SERVICE BULLETIN

Classification:	Reference:	Date:
EC09-025	NTB09-129	November 17, 2009

VENT CONTROL VALVE REPLACEMENT

APPLIED VEHICLES: All Nissan models using Vent Control Valve P/Ns 14935-AM60A / AM60B

<u>New style</u> vent control valve
P/N 14935-JF00A

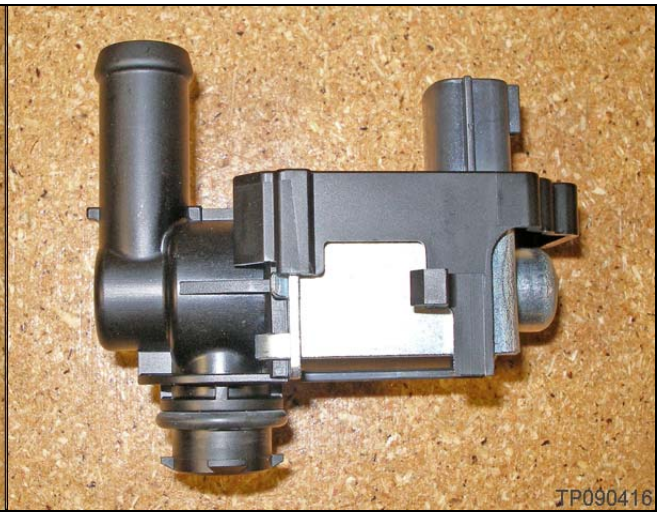
- Use the one listed in the **PARTS INFORMATION** section of this bulletin on Page 2.
- For vent control valve replacement procedure, refer to the appropriate section of the Electronic Service Manual (ESM) if needed.
- When installing the new valve, do not add any lube to its o-ring.
- For Frontier (D40 series) only: install the protector listed in **PARTS INFORMATION**.
  - For protector installation, see the **SERVICE PROCEDURE** section of this bulletin starting on Page 3.
- Make sure to use the **"new style"** valve listed in **PARTS INFORMATION**.

Old style vent control valve
P/N 14935-AM60B

Figure 1

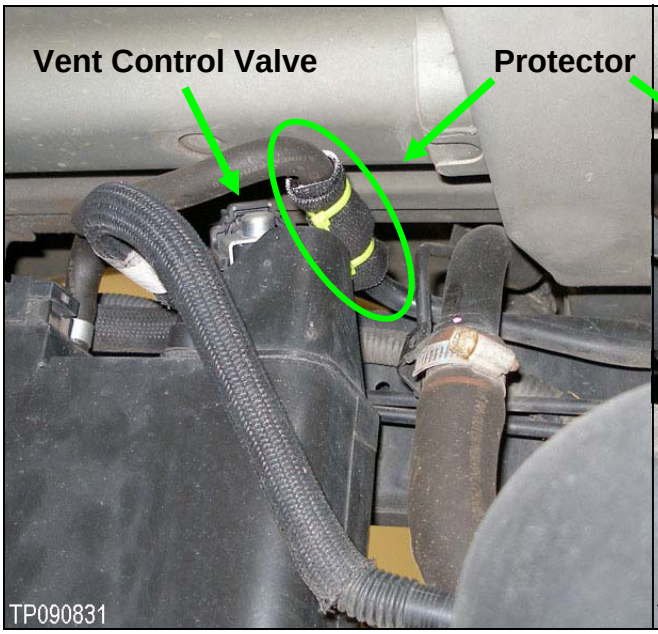
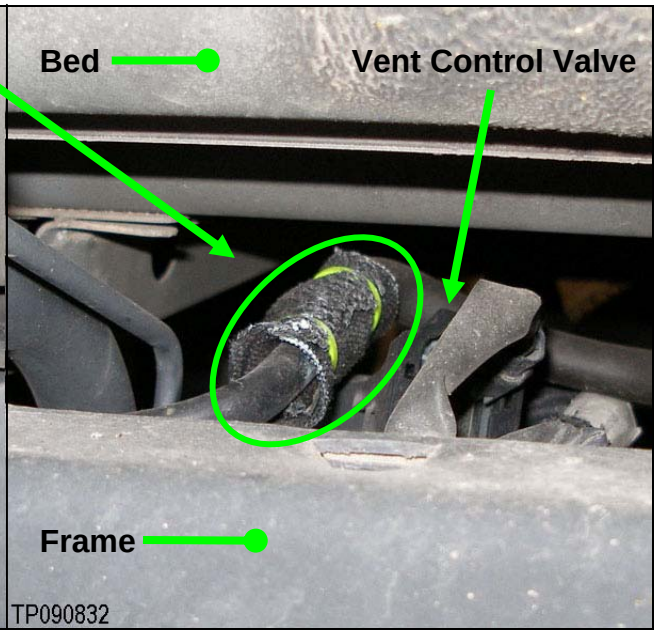
Frontier (D40 series) only: Install Protector

1. Wrap the protector around the EVAP hose (see Figure 1 and 2).
    - Locate the protector between the hose and the vent control valve.
2. Secure the protector with two tie straps.
